Software Upgrade (Revised)

Determine software version.

Photo of U201(AVR MICROPROCESSOR)

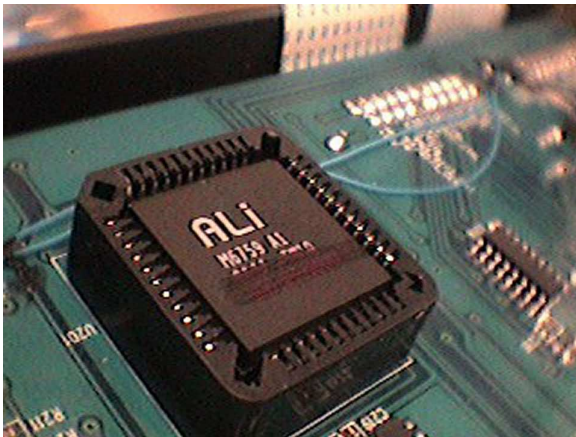
Replacing the microprocessor (see attached photo)

1. Remove the top cover.
2. The front panel is easily removed .The top of the front panel is held in place with four screws on top and five on bottom.
3. Once the screws are removed pull the front panel forward and unplug the ribbon cable on your right side and the four pin connector as well.
4. Unplug the three pin and eight pin cables on the left side.
5. The microprocessor can now be removed.
6. Locate U201 and if required U202, see diagrams for reference.
7. Using a PLCC extractor tool remove the microprocessor.
(Don't use a screwdriver as this may crack the socket!)
8. When inserting the microprocessor line up the dot on the top with the arrow on the socket.
9. Reconnect the cables and secure the front panel.
